NEEDHAM PLANNING BOARD Tuesday June 17, 2025

Re: DPW Complex Phase I Fleet Maintenance Facility: 1407 Central Avenue (Jack Cogswell Building)
Response to Planning Board Comments

Re: Response to Comments—1407 Central Ave. Jack Cogswell Building Addition - Fleet Maintenance

Paraphrased Planning Board Comments

Attachment C Figure 2 – Trip Distribution

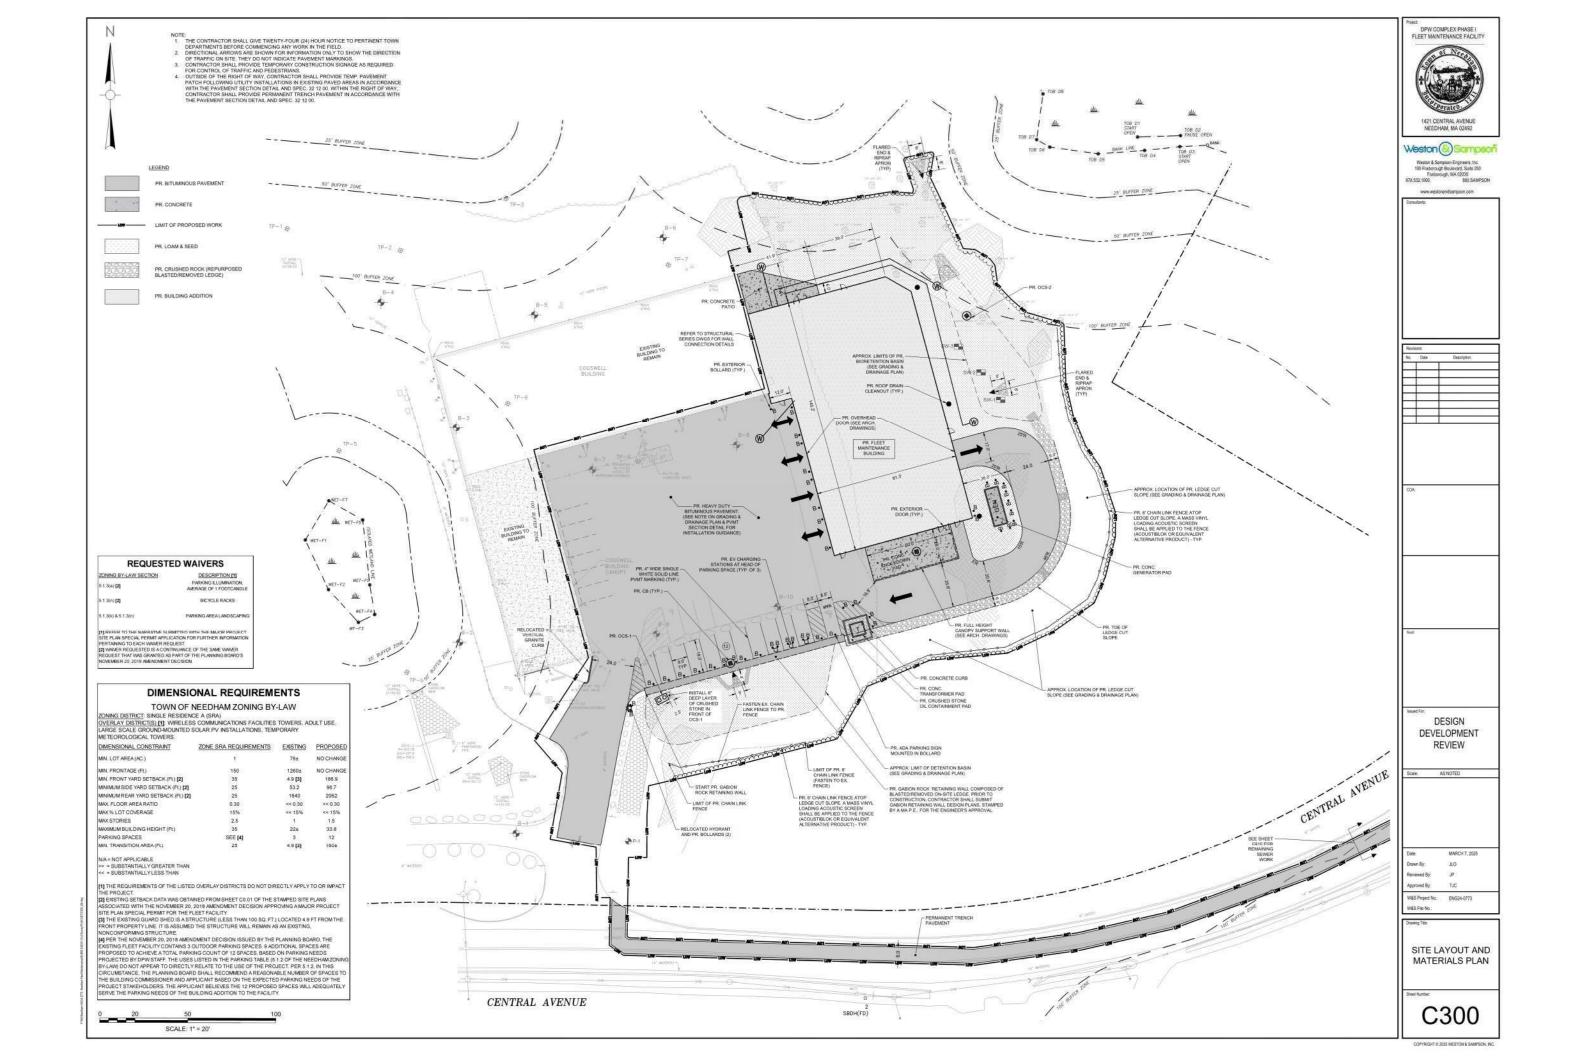
2. Provide clarification on the following items related to the traffic study: how vehicles will be dropped off and picked up; how vehicles will be routed through town to access the fleet maintenance facility; proposed site ingress and egress; confirmation that traffic counts include third-party vendor trips; documentation of stopping sight distances; and a response to concerns from the 2014 traffic study regarding entrance and exit visibility and stopping distances.

To minimize neighborhood impacts, the DPW has proposed a Standard Operating Procedure prohibiting the use of Marked Tree Lane for vehicle drop-offs and pickups related to the Fleet Maintenance Facility. Figure 2 provides for a visual representation of service trips through town.

Attachment B Figure 1 – Proposed Entrance and Exit Diagram

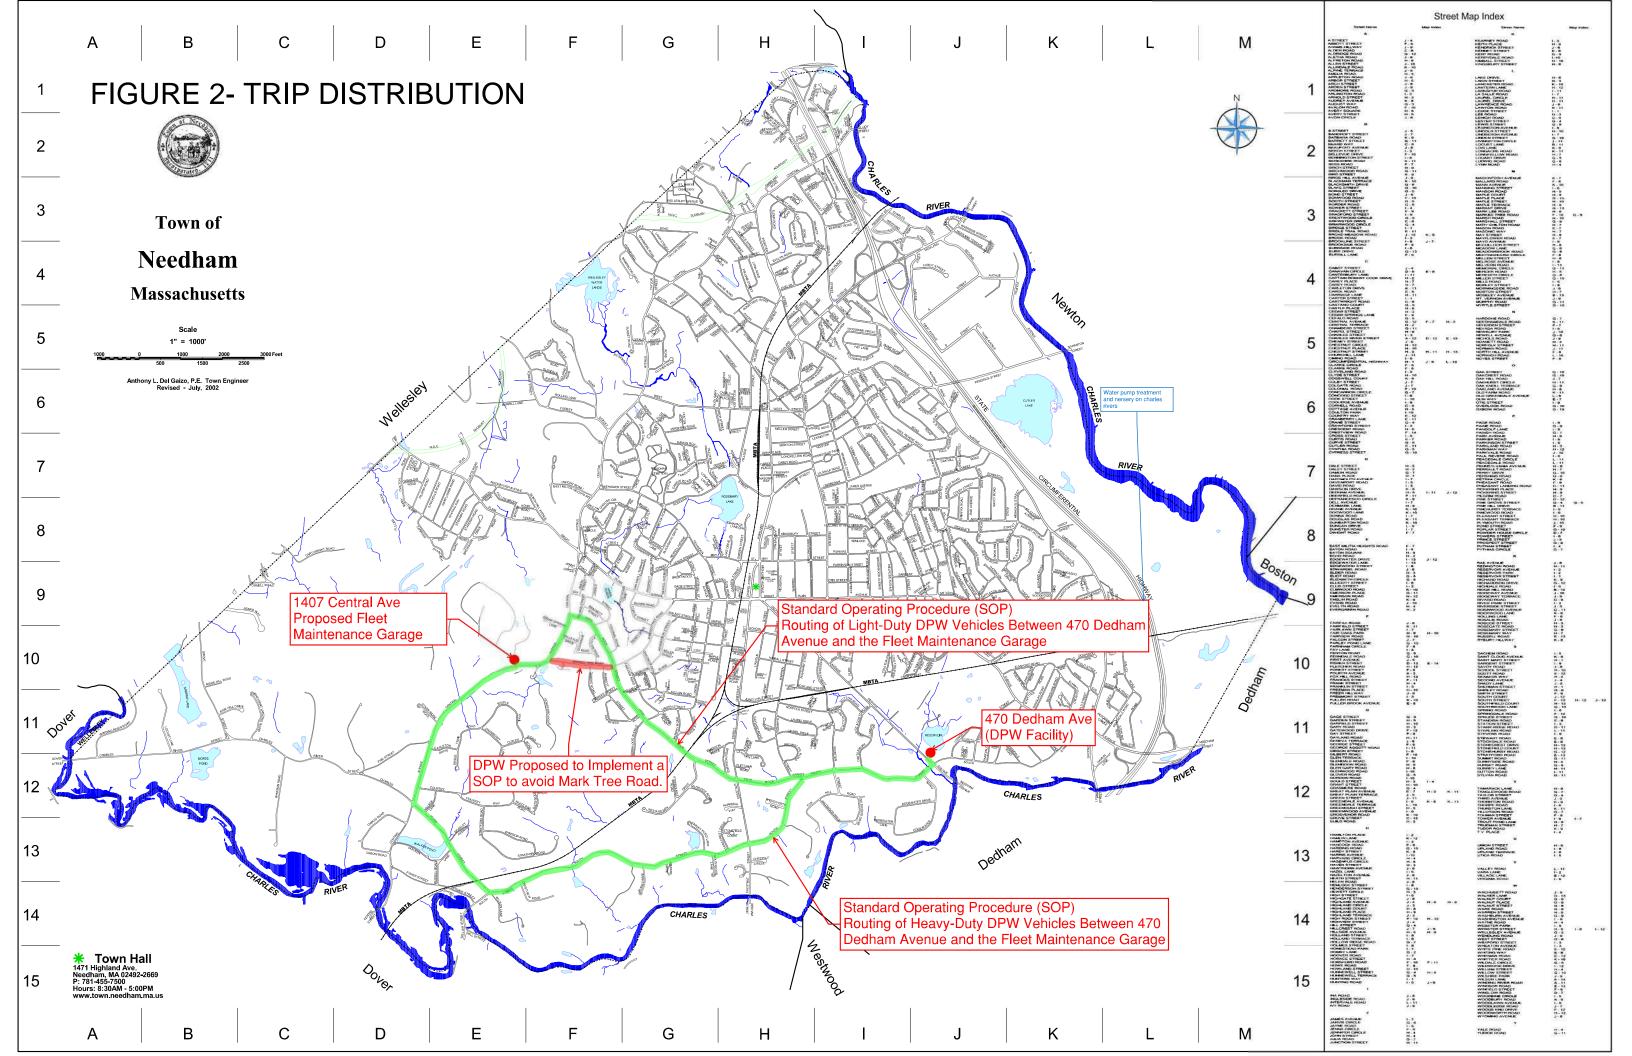
During the Planning Board hearing, there was concerns raised regarding the adequacy of sight distance at the third from the east driveway on Central Avenue, which is one of the two driveways the new fleet maintenance facility will use to exit onto Central Avenue. Sight distance methodology is established within the *Policy on Geometric Design of Highways and Streets* manual published by the American Association of State Highway and Transportation Officials (AASHTO)¹. Stopping sight distance is considered the minimum required visibility to safely stop before an obstruction. Intersection sight distance is the recommended sight distance which is based on the visible distance needed to allow an entering vehicle from the driveway to not cause an approaching vehicle on Central Avenue to reduce its travel speed to less than 70% of the roadway design speed. The calculations are based on the posted speed, design speed (if different), or 85th percentile speed (if measured). The posted speed limit on Central Avenue is 30 miles per hour and the 85th percentile speed was measured as 38-39 miles per hour over the 2 days recorded.
